Access Compliance Report

Public Rights-of-Way

(Curb Ramps)

Intersection ID: 3825	Main Street: GARRISON_RD	Cross Street: LADORA_DR	Location:	N
ADA ID: 7C51929A0EA0	Ramp Type: PerpDiag	Initial Pass/Fail: Fail	Overall Compliance: No	Severity Score: 17.5
Codes/Mitigation Info/Possible Solution		Field Measurements/Component Compliance

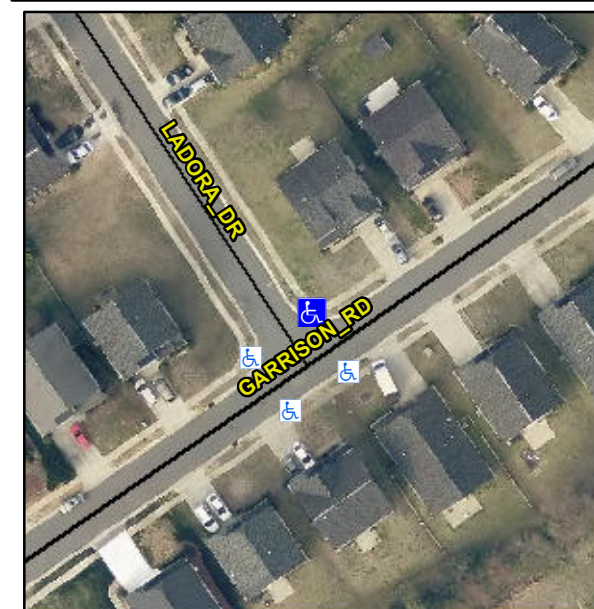
Not Found, R304.5.1

Compliance	Description	Data	Compliance	Description	Data
N/A	Ramp Length (in)	48.5	Yes	Ramp Slope (%)	6.6
No	Ramp Width (in)	35.0	Yes	Ramp XSlope (%)	1.0
N/A	Flare Type LT	N/A	N/A	Flare Type RT	N/A
N/A	Flare Slope LT (%)	N/A	N/A	Flare Slope RT (%)	N/A
N/A	Flare Traversable LT?	N/A	N/A	Flare Traversable RT?	N/A
N/A	Landing Length (in)	N/A	N/A	DWS Provided?	N/A
N/A	Landing Width (in)	N/A	N/A	DWS Contrast?	N/A
N/A	Landing Slope (%)	N/A	N/A	DWS Length (in)	N/A
N/A	Landing X Slope (%)	N/A	N/A	DWS Full Width?	N/A
N/A	Landing Curb? (Y/N)	N/A	N/A	DWS Offset (in)	N/A
N/A	Shared Landing?	N/A			
N/A	Gutter Ponding?	N/A	N/A	Gutter Slope (%)	N/A
N/A	Gutter Lip Ht (in)	N/A	N/A	Gutter X Slope (%)	N/A
N/A	Painted X Walk1?	No	N/A	Painted X Walk2?	No
	X Walk 1 Direction	To SW		X Walk 2 Direction	To SE
N/A	X Walk 1 Width (in)	N/A	N/A	X Walk 2 Width (in)	N/A
	X Walk 1 Slope (%)	4.8		X Walk 2 Slope (%)	2.7
	X Walk 1 X Slope (%)	0.5		X Walk 2 X Slope (%)	2.4

Remove & Replace Curb Ramp With Two New Directional Ramps or Equivalent.
